City of Albuquerque

March 21, 2002

RE: JIFFY LUBE- OFFICE BLDG. (A-14/D15)
(3520 Calle Cuervo NW)
ENGINEERS CERTIFICATION FOR CERTIFICATE OF OCCUPANCY
ENGINEERS STAMP DATED 8/23/2001
ENGINEERS CERTIFICATION DATED 3/21/2002

GRADING AND DRAINAGE PLAN
OFFICE BUILDING - JIFFYLUBE
3520 CALLE CUERVO NW
ALBUQUERQUE, NEW MEXICO

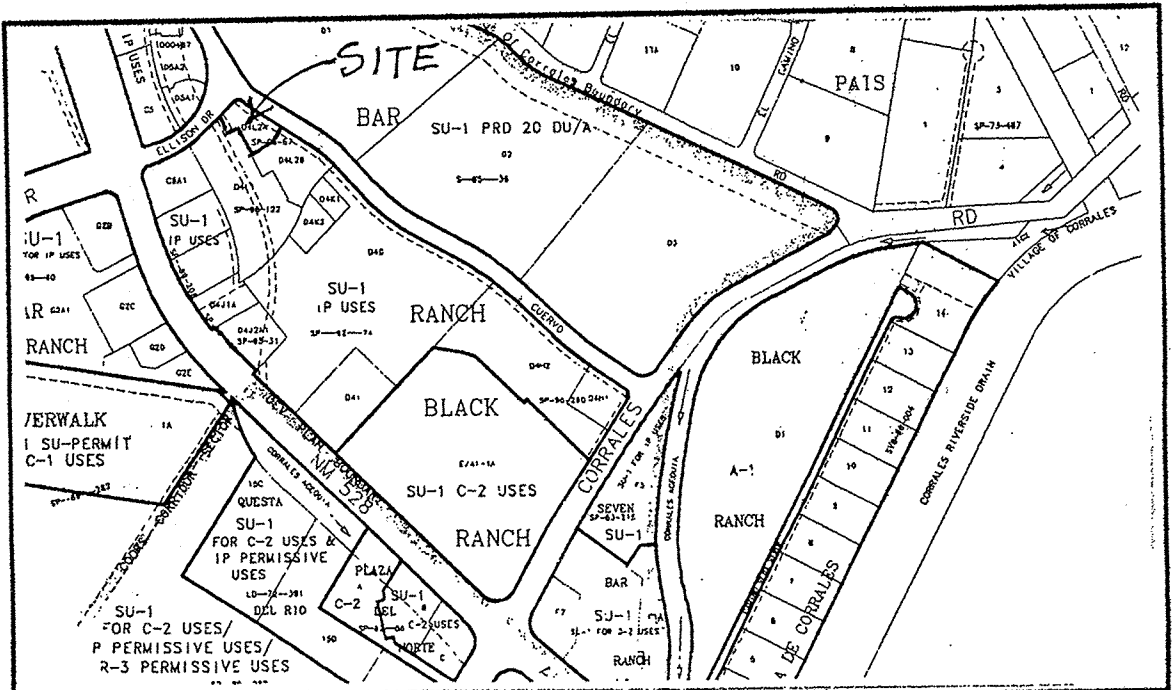
Based upon the information provided in your Engineers Certification submittal dated 3/21/2002, and the SO19 approval dated 3/20/2002, the above referenced site is approved for a Permanent Certificate of Occupancy.
